# UNITED STATES PATENT AND TRADEMARK OFFICE

APPLICATION NO.	FILING DATE	FIRST NAMED INVENTOR	ATTORNEY DOCKET NO.	CONFIRMATION NO.
10/717,146	11/18/2003	Sudhir K. Madan	TI-34845	6785
23494	7590	10/08/2004	EXAMINER MAI, SON LUU	
TEXAS INSTRUMENTS INCORPORATED P O BOX 655474, M/S 3999 DALLAS, TX 75265			ART UNIT 2818	PAPER NUMBER

<b>Office Action Summary</b>	<b>Application No.</b>	<b>Applicant(s)</b>	
	10/717,146	MADAN, SUDHIR K.	
	<b>Examiner</b>	<b>Art Unit</b>	
	Son L. Mai	2818

3. Claims 1-45 are rejected under 35 U.S.C. 102(b) as being clearly anticipated by U.S. Patent 5,675,530 issued to Hirano et al. (hereinafter referred to as "Hirano").

FIG. 5

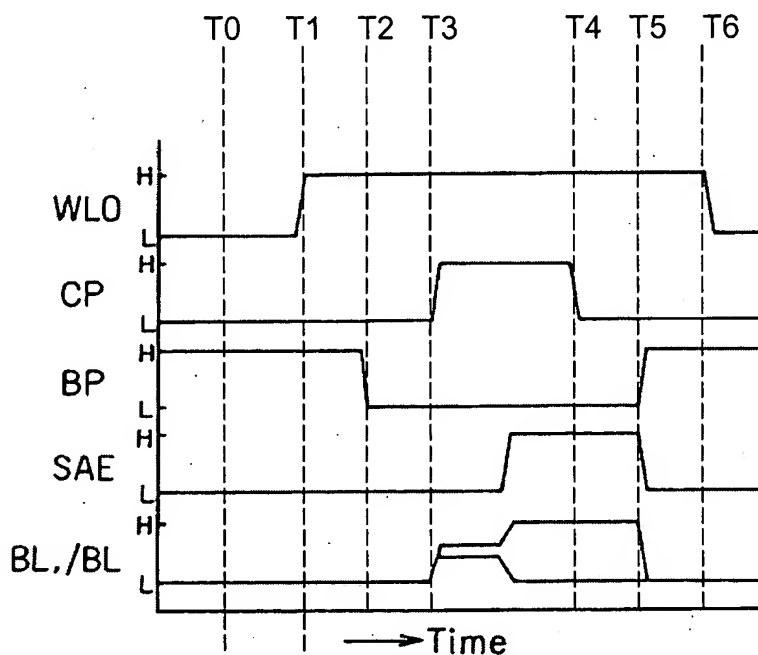
Regarding claim 1, Hirano discloses a method of operating a memory circuit comprising the steps of: activating a precharge signal (BP at time T0 in fig. 5) applied to a precharge circuit (QnBP0-QnBP2) to precharge a bitline to a predetermined voltage (Vss); activating a first control signal (WL0 at time T1) from an inactive state while the precharge signal is active, the first control signal applied to a control terminal of a memory cell transistor (Qn0), the memory cell transistor having a current path connected to the bitline; and inactivating the precharge signal (at time T2) while the first control signal is active.

Regarding claim 4, the step of inactivating the first control signal (WL0) while the precharge signal (BP) active is shown at time T6.

Regarding claim 5, the step of activating from an inactive state, a second control signal (CP) applied to the memory cell after the step of inactivating the precharge signal is shown at time T3.

Regarding claim 6, the step of inactivating the second control signal (CP) while the first control signal active occurs at time T4; and the step of activating the precharge signal (BP) while the first control signal active and the second control signal inactive occurs at time T5.

Regarding claims 9 and 10, Hirano shows in figure 5, the step of activating a precharge signal (at time T0) precharging the bitline (BL) and a complementary bitline (/BL) to the predetermined voltage (Vss).
